June 28, 2022

OAKLEDGE UNIVERSALLY ACCESSIBLE PLAYGROUND CONSTRUCTION *Addendum 3*

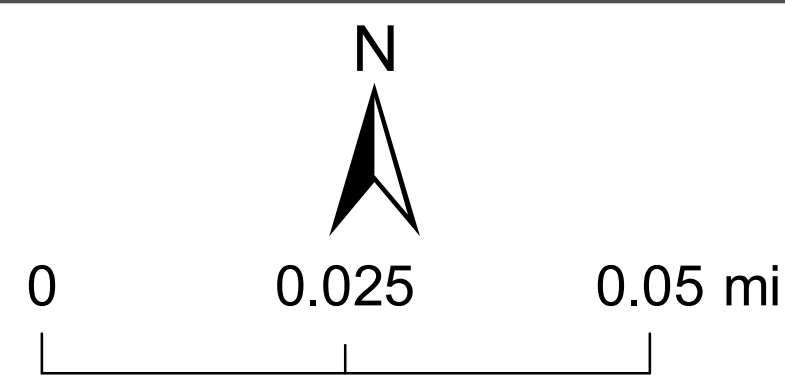
10. Please double check your excavation, fill, and gravel quantities. Our takeoffs show substantially different quantities.

Please note as an exception in the bid and list revised quantity & corresponding bid calculation in table.
